Dam Failure ISG - NRC Response to NEI Comments – Last Updated 4/15/13

NRC Interim Staff Guidance on Estimating Flooding Hazards Due to Dam Failure

JLD-ISG-2013-01

Figure 1. Levels of Analysis

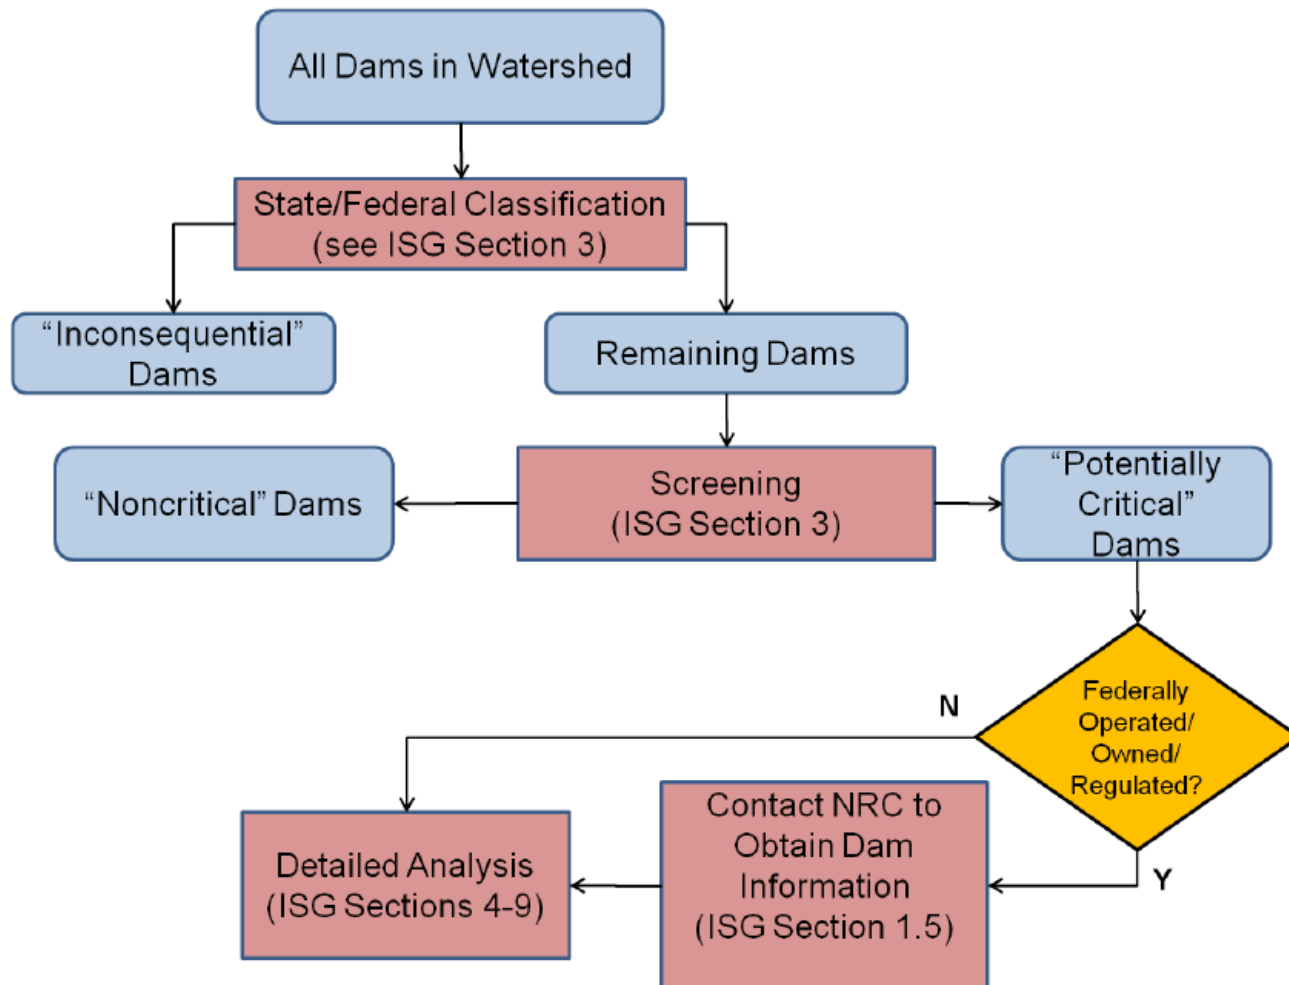
Section / Page	Comment	Concern	Proposed Resolution	[Draft] NRC Response
	in the analysis, and “noncritical” dams, which are “screened out” (Figures 10-13) but whose postulated failure effects are carried forward in the analysis. The terminology used in the ISG seems to be inconsistent; e.g., the 1 st sentence of Section 3 states “This section discusses screening criteria used to identify those dams that may be screened out and not given further consideration in the analysis.” The term “screened out” as applied in this sentence and in Figures 10-13 clearly means something different.		consideration and no effects of their postulated failures are included in the final dam failure analysis. However, the cumulative, conservative effects of postulated failures of non-critical dams are carried forward in the analysis (e.g., last sentence of Item 1.d, p. 24). Further clarification on this topic near the beginning of the section would be helpful. Fig. 1 from Section 1 could be reproduced here, or at least referred to. The ISG needs to use precise terminology; the text should be revised to apply the terms “screened” and “screened out” consistently. A suggested change would be to use the term “removed” only for inconsequential dams and the term “screened out” only for noncritical dams. Also, a discussion of how the effects of noncritical dams are to be carried forward and used in the final analysis is needed.	<p>Note: Look at providing additional guidance on how to add in cumulative effects.</p> <p>Text modified in several places to tighten up wording. “Inconsequential” dams are “removed”. “Noncritical” dams are “screened”.</p> <p>Provided cross reference to Section 1.3.1 and Figure 1.</p>

Figure 10. Screening Method Flowchart (a) – Method 1 (Volume)

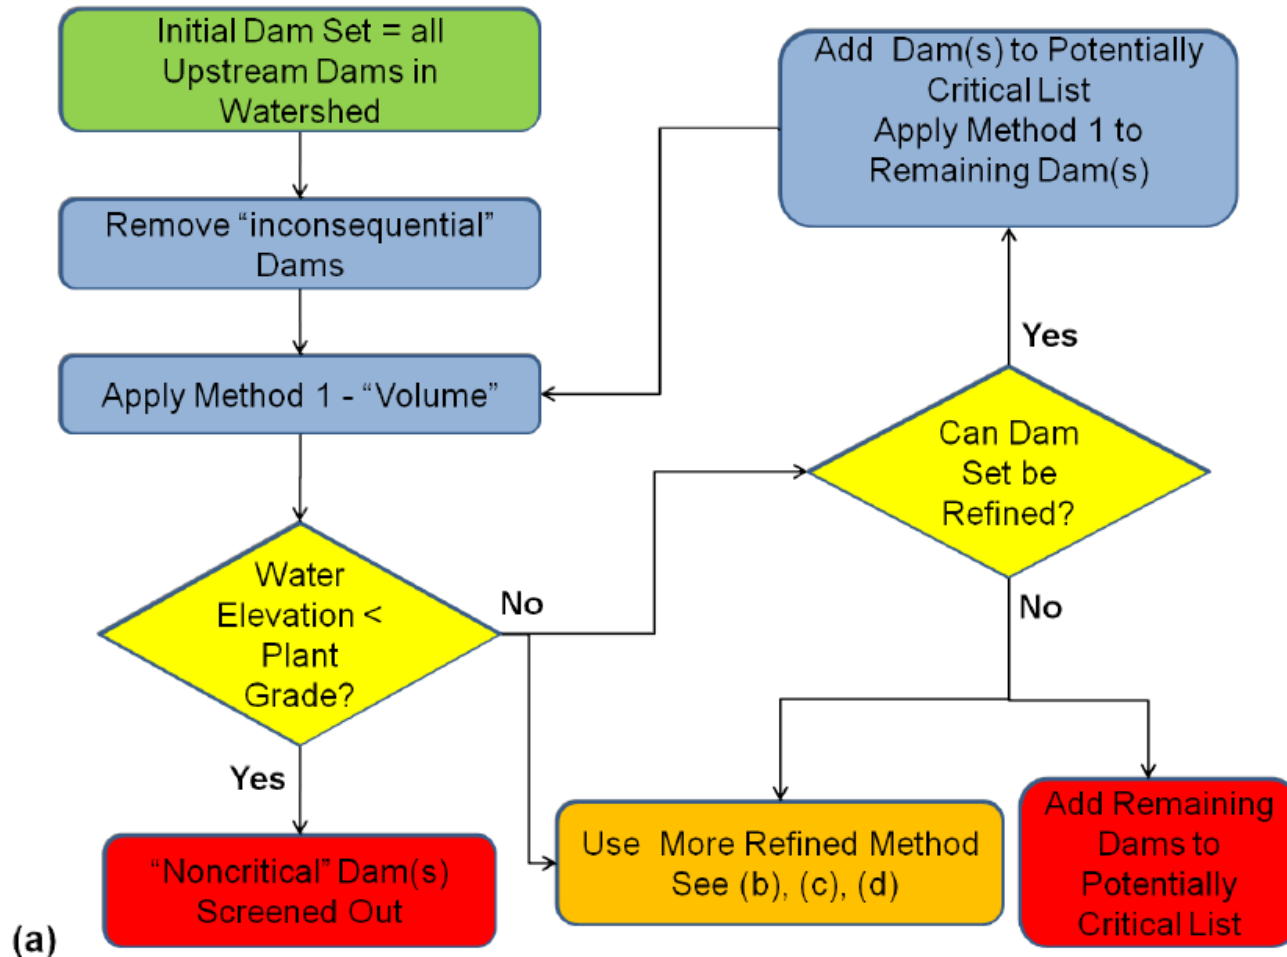
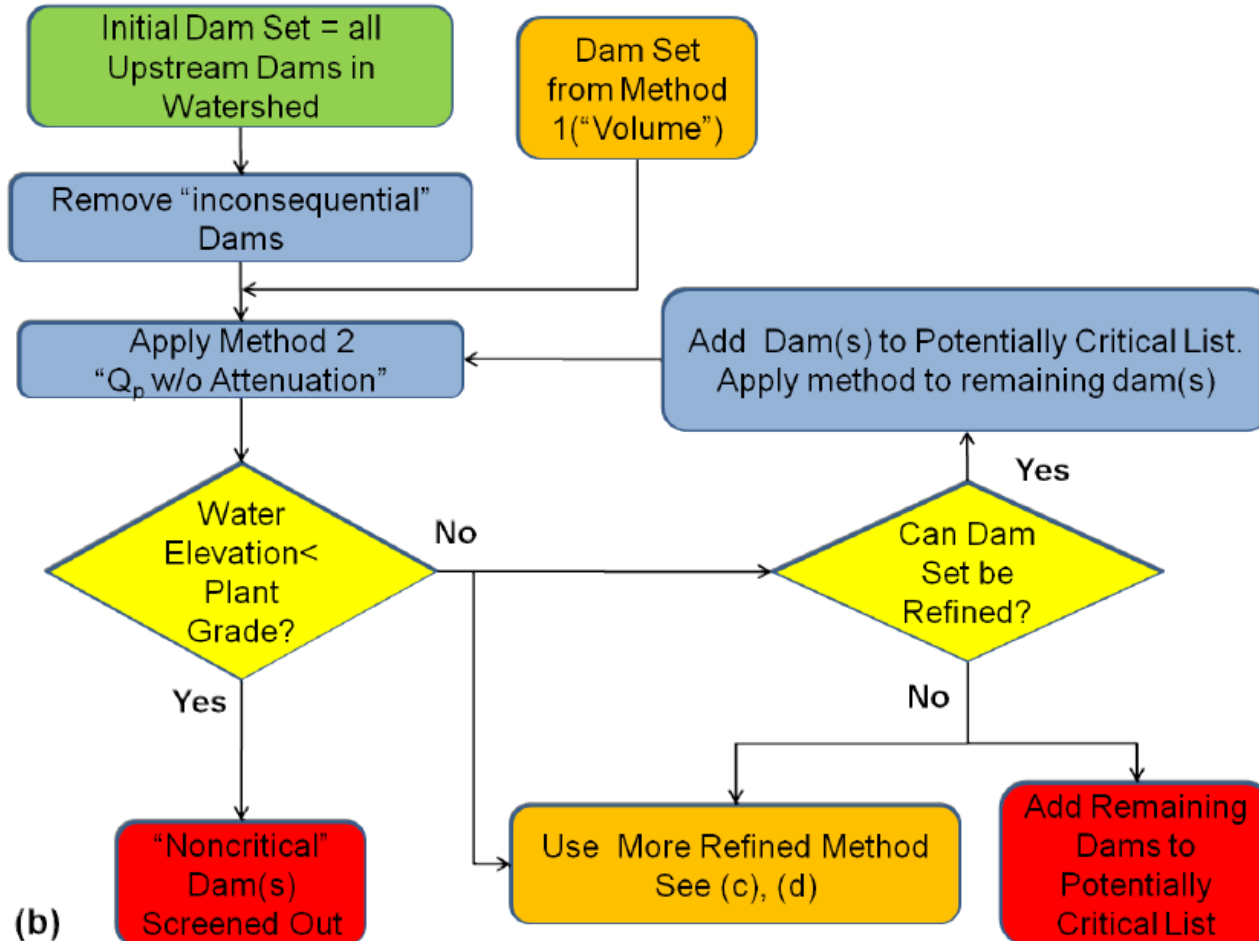
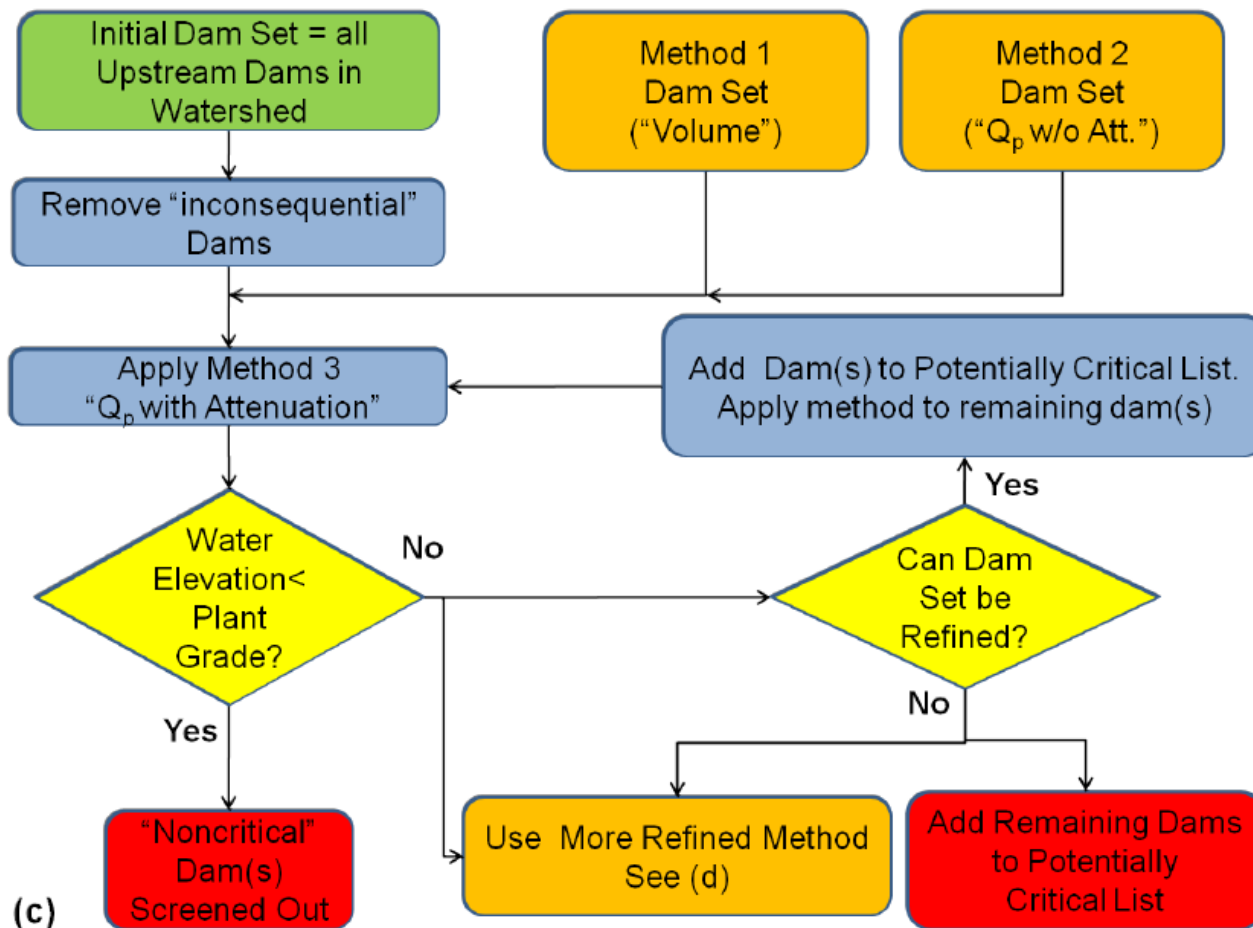
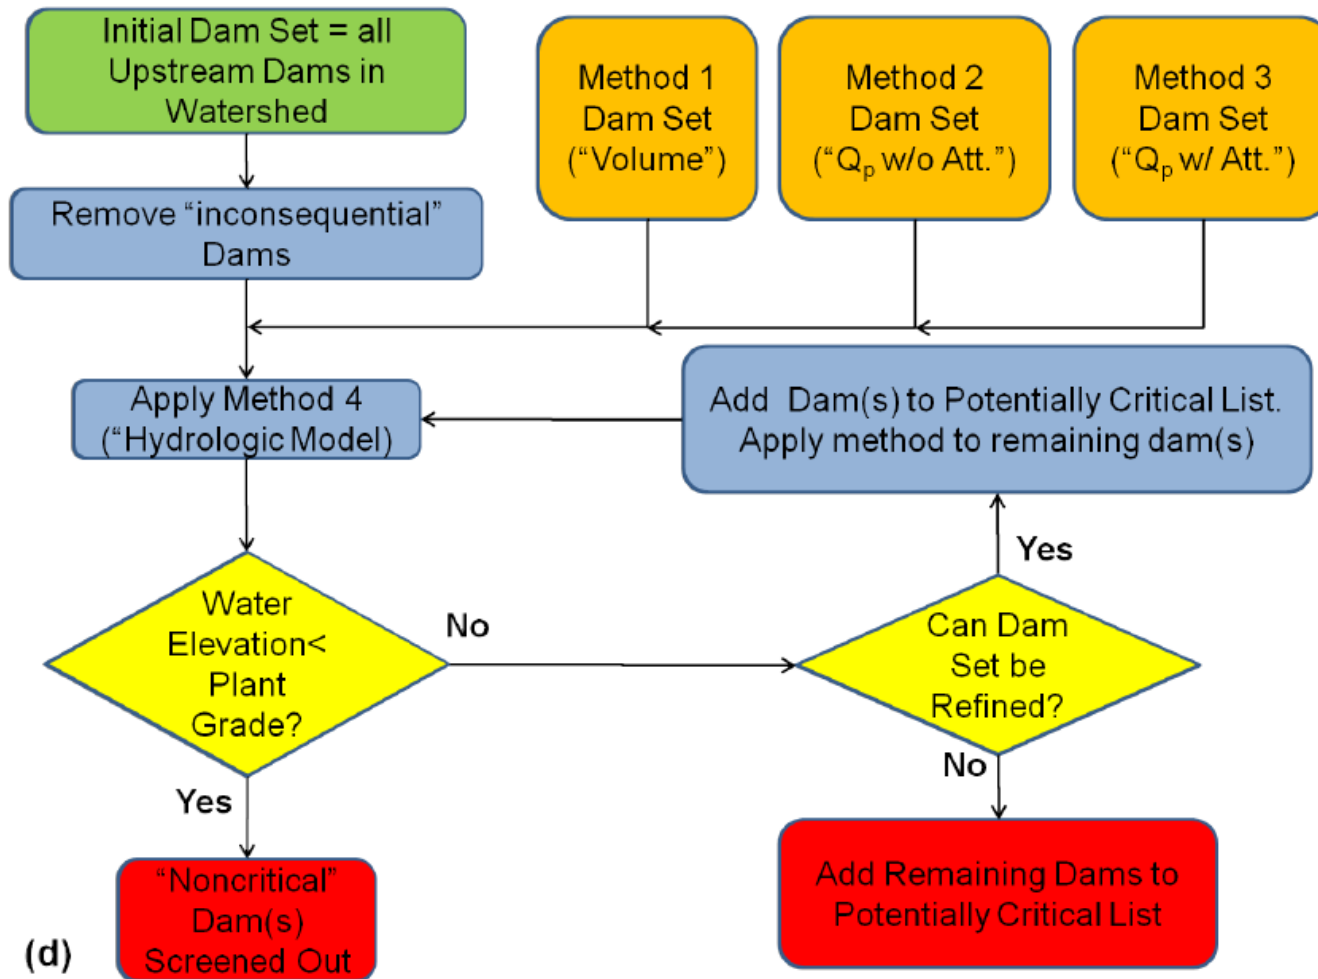
Sec. 3 / p. 23	General comment: There needs to be a clearer distinction between "inconsequential" dams, which are removed from consideration	Clarity of important subject.	According to the ISG, inconsequential and noncritical dams are not treated the same. Inconsequential dams are removed from	Will review this section and tighten up wording.
